Urgent FIELD SAFETY NOTICE

Device: **Terumo® Advanced Perfusion System 1 = Roller Pump Tube Clamp**
 Reference: **FSN1105 2011-07 [EN]**
 Action: **Advisory**

FSN1105A [EN]

Addendum

Figure a.

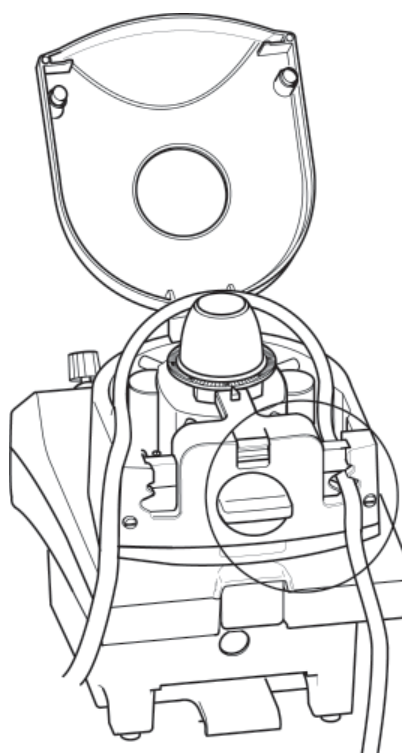
1. Load tubing in the roller pump. Confirm the proper operation of the tube clamp mechanism by turning the tube clamp dial half the distance of its travel and observe the sliding movement of the upper and lower tube clamp slides on each side of the tube clamp mechanism. If the tube clamp slides retract, the tube clamp is functioning properly.
2. If the lower tube clamp slide mechanism does not retract, change out the roller pump.
3. To change out the roller pump:
 - a) Remove the tubing from the unaffected side of the tube clamp mechanism as shown in Figure a.

Figure b.

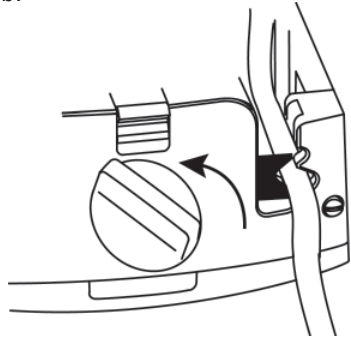
- b) Retract the upper tube clamp slide into the housing on the affected side by turning the tube clamp dial to open as shown in Figure b.

Figure c.

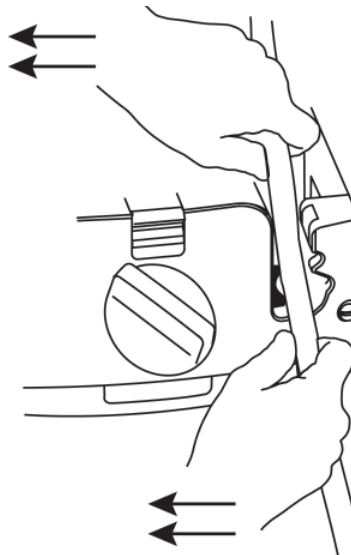
- c) Grasp the tubing on both sides of the broken tube clamp slide and force the tube clamp slide open toward the center of the tube clamp as shown in Figure c.

Figure d.

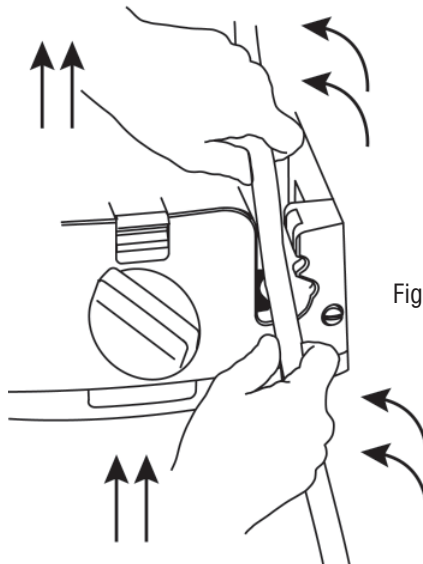
- d) Hold the slide open and apply an upward, twisting force to the tubing in the failed lower tube clamp slide mechanism as shown in figure d. Remove the tubing.
